January 21, 2016

**Re: Catholic Charities**  
**2034 Bridge Blvd., SW**  
**Traffic Circulation Layout**  
Engineer's/Architect's Stamp dated 1-9-16 (L12-D012)

Based upon the information provided in your submittal received 1-20-16, the above referenced plan cannot be approved for Building Permit until the following comments are addressed:

A1 TRAFFIC CIRCULATION LAYOUT AND SITE DIMENSION PLAN

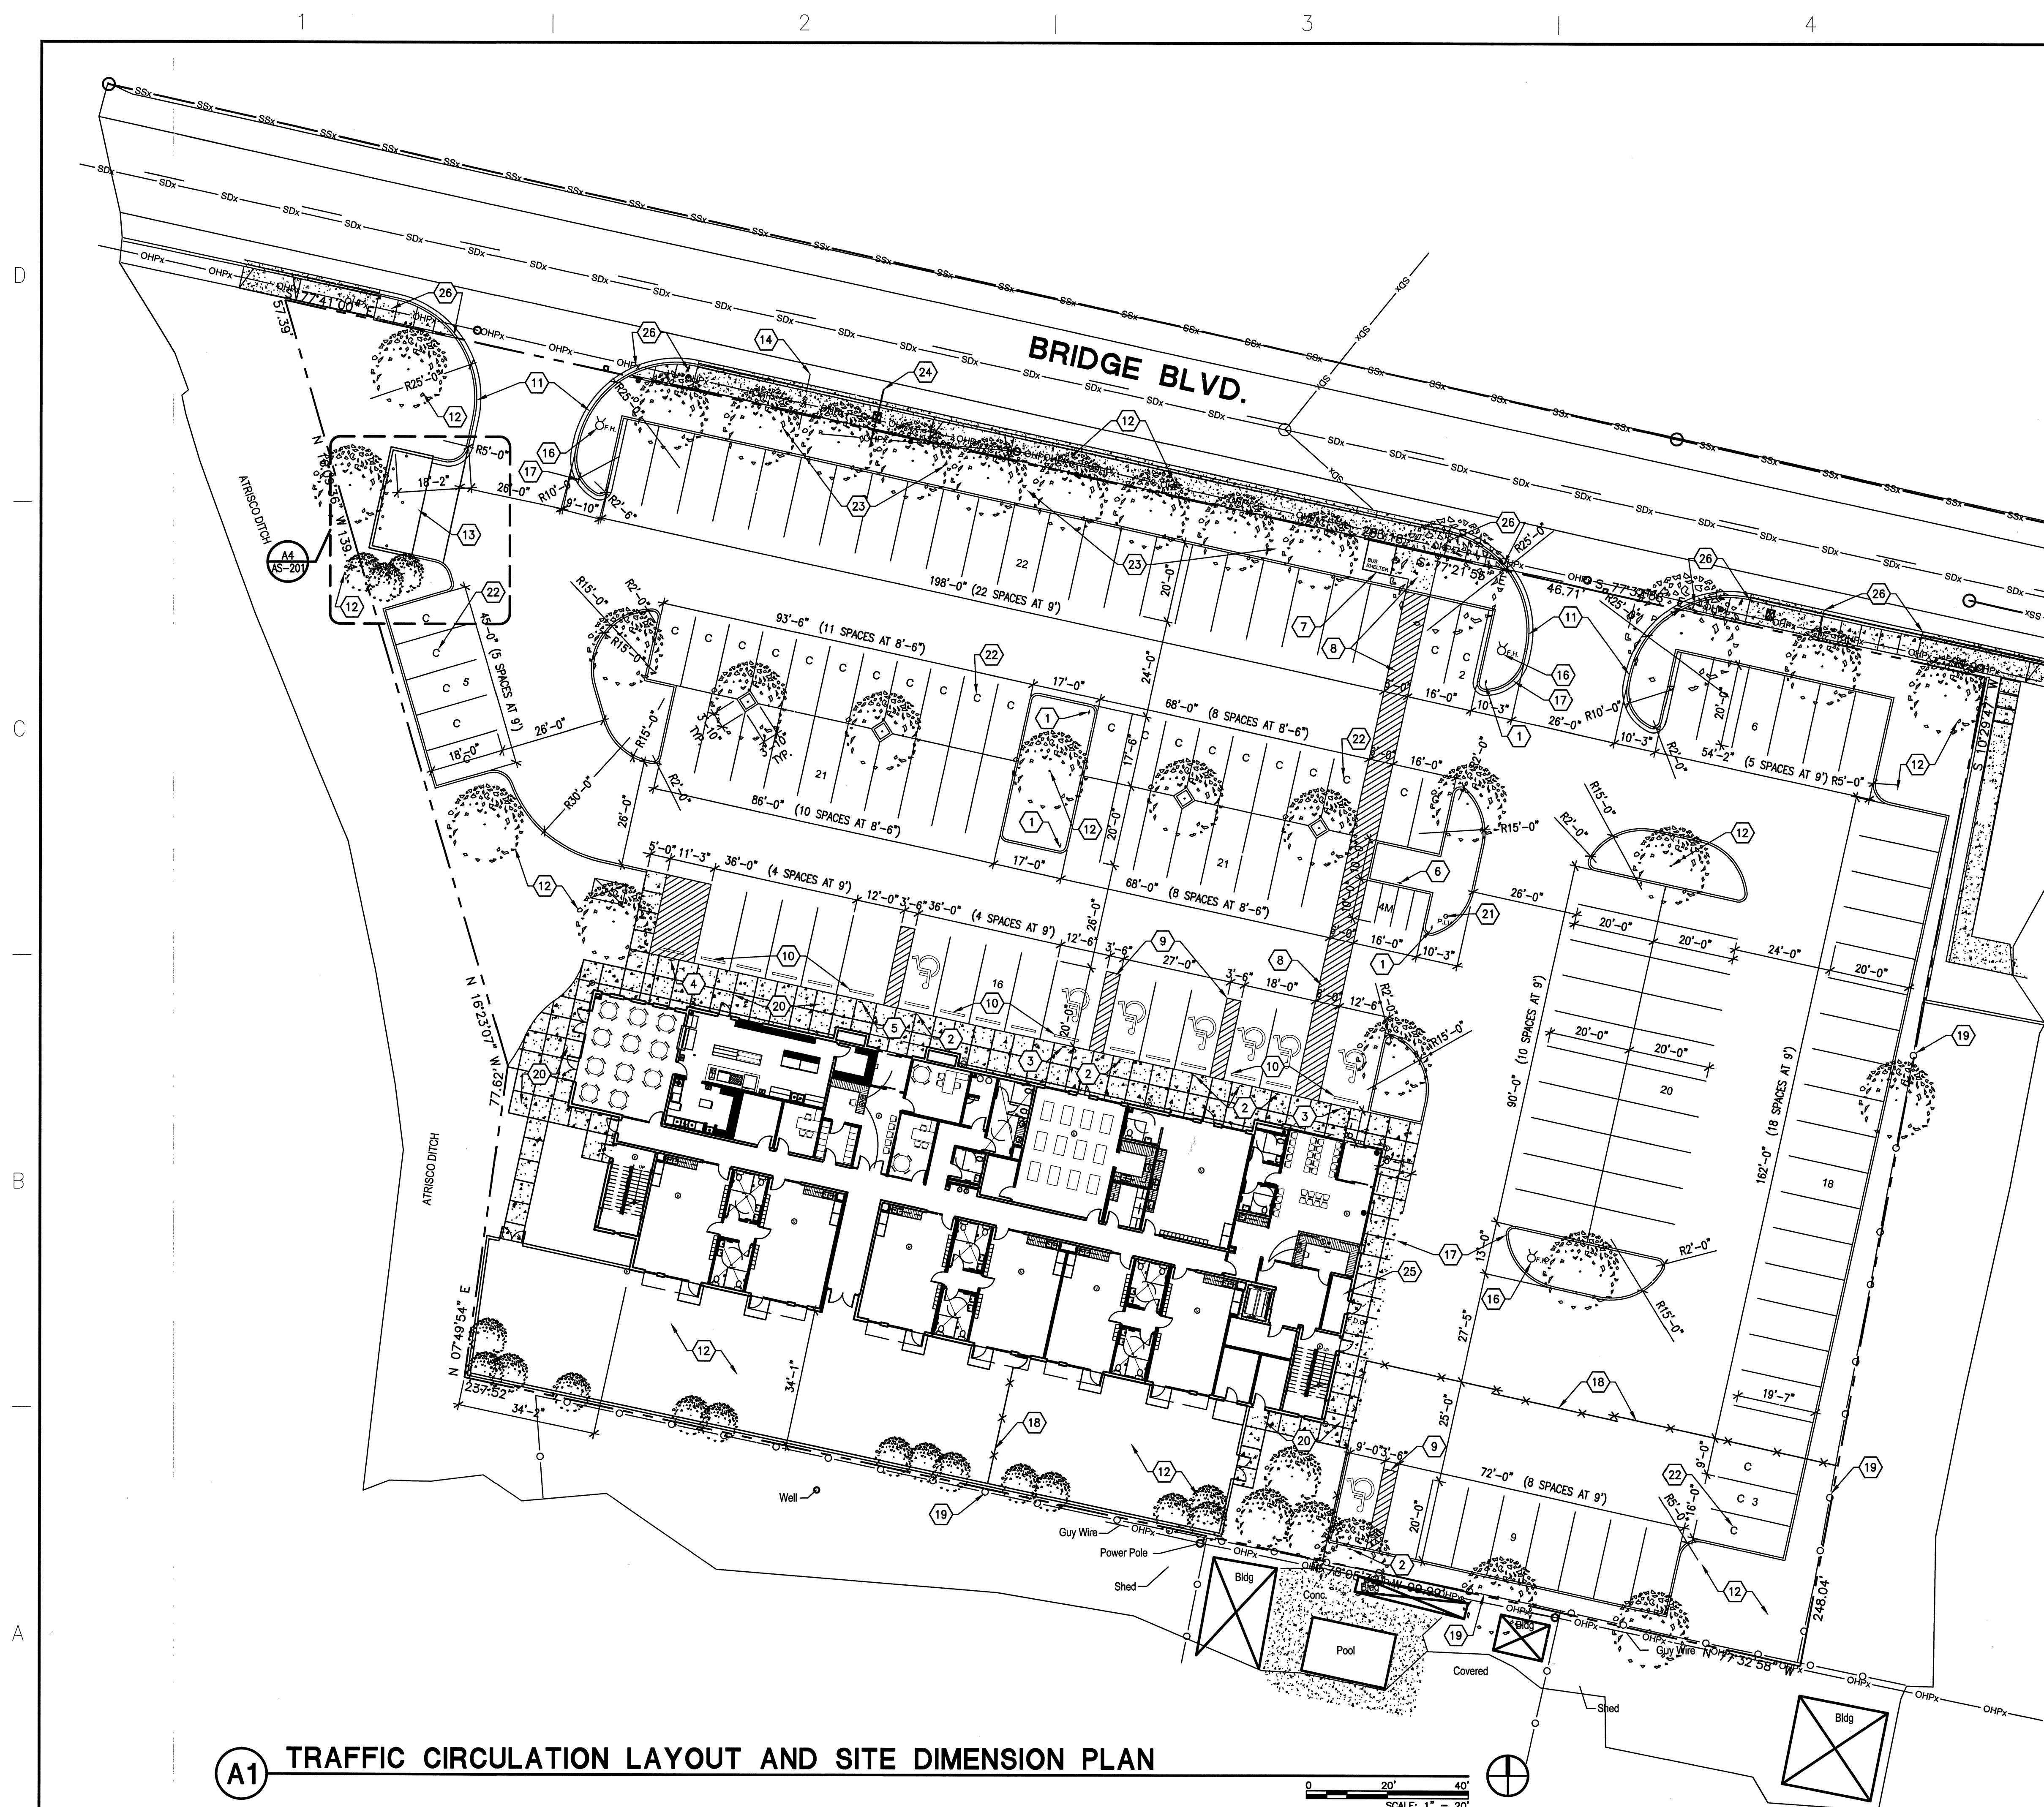
1. Please show a vicinity map showing the location of the development in relation to streets and well known landmarks. Please clearly show the lots proposed in the project.

2. Clarify the extents of the current phase.
3. Identify the right of way width, medians, curb cuts, and street widths on Bridge Blvd.
4. Clearly detail sidewalk, curb cuts and handicap ramps along Bridge Blvd.(Key Note #26) Truncated domes are required at handicap ramps in the public right-of-way at curb cuts.

5. The handicap accessible spaces must include an 8-foot wide van access aisle; all other aisles should be 5 feet in width. In review of submitted drawing the access isle are shown to be 3.5 ft. in width(Key Note #9).

6. Per provided parking calculations, the site requires two ADA van accessible parking spaces with accessible isles. Please reconfigure parking spaces to accommodate the required van accessible parking spaces.

7. The ADA accessible parking sign must have the required language per 66-7-352.4C NMSA 1978 **"Violators Are Subject to a Fine and/or Towing."**
8. The ADA access aisle shall have the words **"NO PARKING"** in capital letters, each of which shall be at least one foot high and at least two inches wide, placed at the rear of the parking space so as to be close to where an adjacent vehicle's rear tire would be placed. (66-1-4.1.B NMSA 1978)

9. Per the DPM, a 6 ft. wide ADA accessible pedestrian pathway is required from the HC parking stall access aisles to the building entrances. Please clearly show and dimension this pedestrian pathway from the ADA parking space on the south side of proposed building to the building entrance.

10. Label the compact parking spaces by placing the words “**COMPACT**” on the pavement of each space.
11. Provide a min 6" or max 8" high concrete barrier curb or other acceptable barrier between landscaping and parking areas and/or drive aisles. Please call out the dimension of the proposed concrete barrier curb.
12. Design delivery vehicle route needs to be shown.
13. Service vehicle and/or refuse vehicle maneuvering must be contained on-site; provide a copy of refuse approval.
14. It is not apparent what type of pavement surface is being proposed. A hard driving surface will be required as part of this proposed project for parking area and drive aisles.
15. Please provide a sight distance exhibit (see the *Development Process Manual, Chapter 23, Section 3, Part D.5 Intersection Sight Distance*). Please call out this detail for both entrances/exits off of Bridge Blvd.

16. Please add the following note to the clear sight triangle: “Landscaping and signage will not interfere with clear sight requirements. Therefore, signs, walls, trees, and shrubbery between 3 and 8 feet tall (as measured from the gutter pan) will not be acceptable in this area.”
17. Unused curb cuts must be replaced with sidewalk and curb & gutter. A build note must be provided referring to the appropriate City Standard drawing.
18. All broken or cracked sidewalk must be replaced with sidewalk and curb & gutter. A build note must be provided referring to the appropriate City Standard drawing.
19. Please include two copies of the traffic circulation layout at the next submittal.
